Date:	June 8, 2026
State Project #:	089-0172
Project Name:	Smith Elementary School
Project Location:	142 Rutherford St., New Britain CT 06051

CLARIFICATIONS

LANGUAGE ROOMS ACOUSTIC PANELS

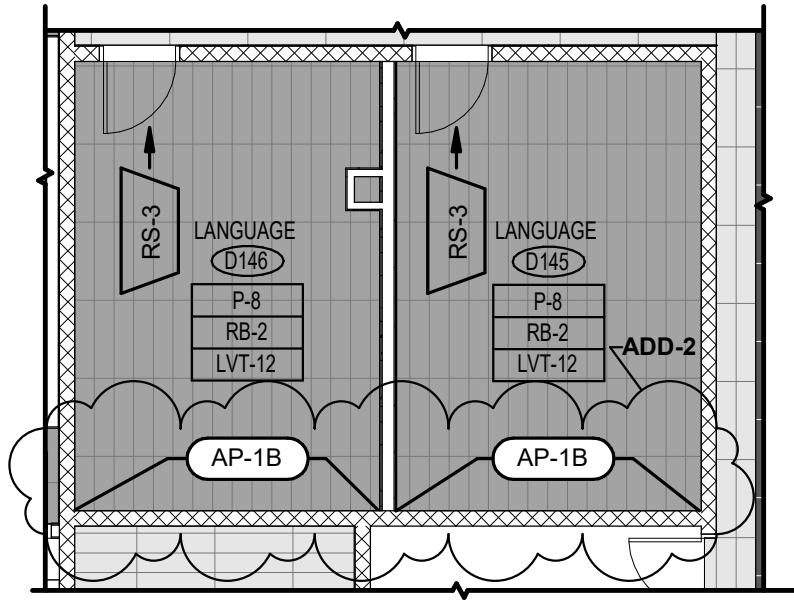
145	6/2/2026	HCarr	1.14	Bull 1.02	On drawing A12.09 and A12.08 there are designations for ap-1b at some of the language rooms but not all the language rooms(room D145 & D146 do not have a notation for ap-1b). Please confirm that all language rooms should have wall panels on one wall of the room? There also does not appear to be any elevations provided for these language rooms. Please provide an elevation for panel layout.	KBA	All Language Rooms to receive acoustical wall panels. Refer to detail 8/A12.27 for panel elevations.

OUTLET CONTROL STRUCTURE (OCS)

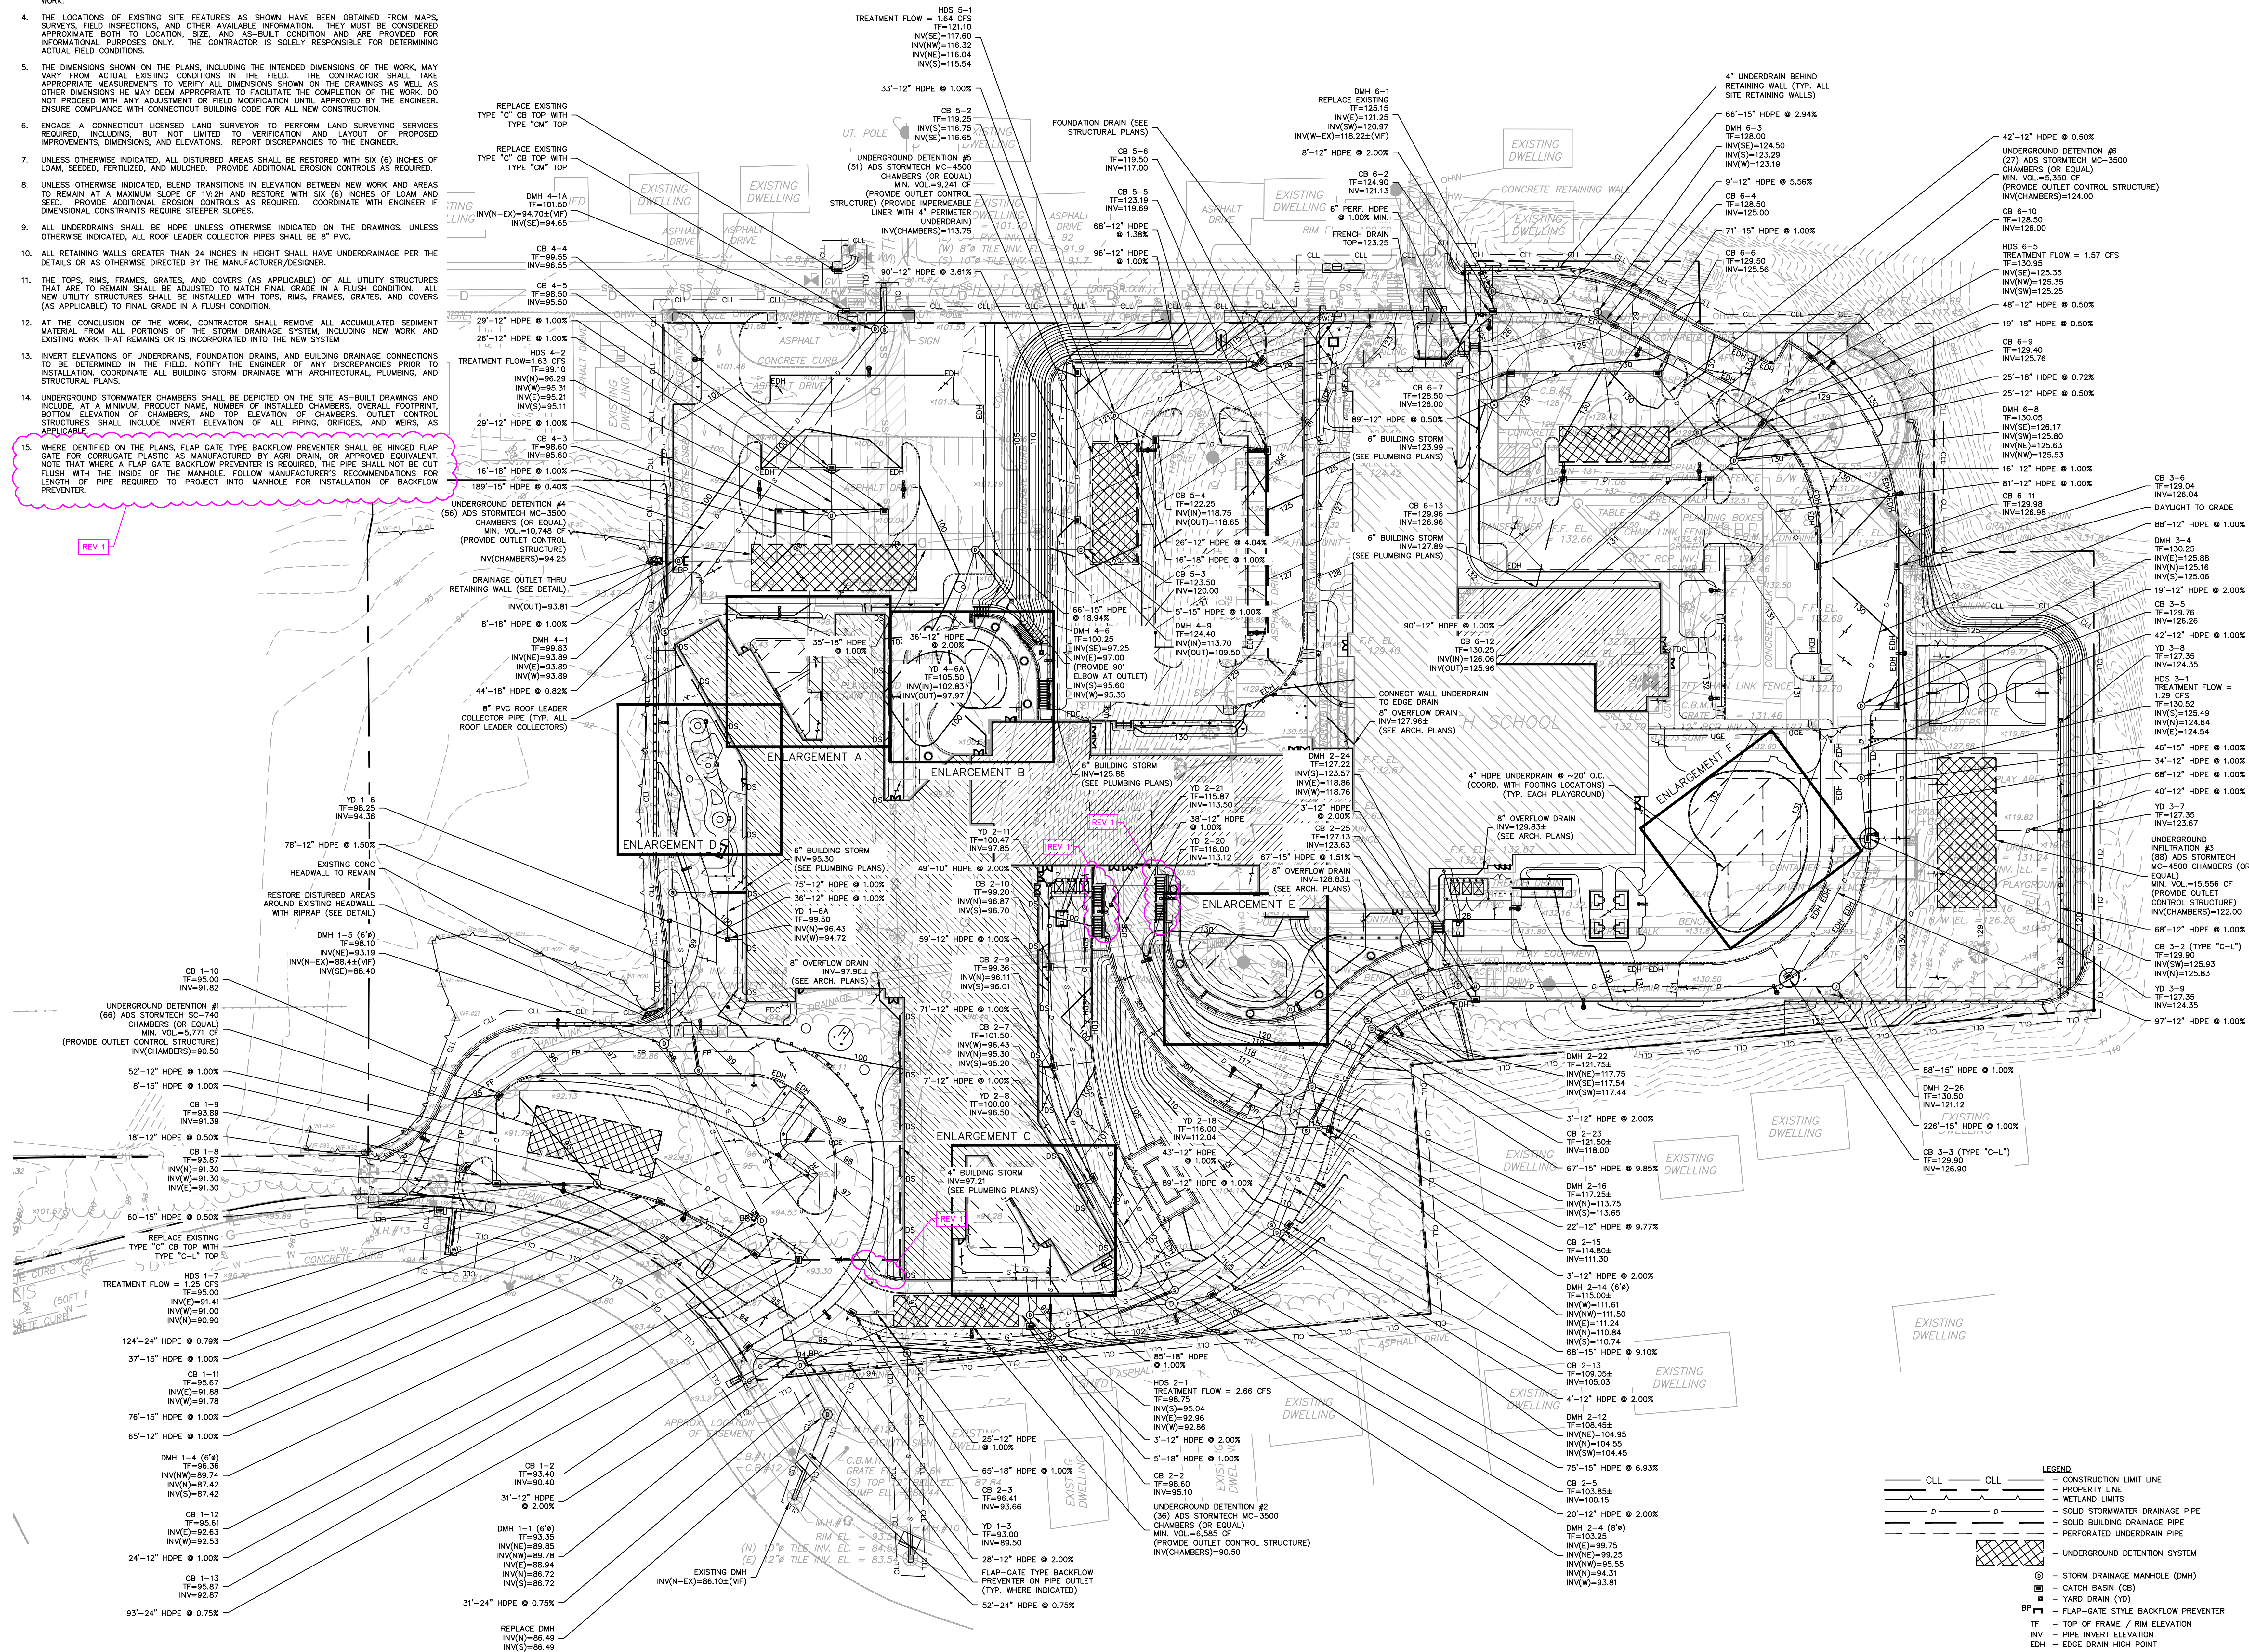
076	6/1/2026	Mather	1.03	Bull 1.01	Dwg. C7.02- OCS Structures Chart- please clarify where these structures would be located on drawing C4.01.	KBA	OCS structure numbers correspond to the underground detention system numbering. Follow the manufacturer's recommendation for configuration of outlet control. Can be located within the structure footprint or just outside.
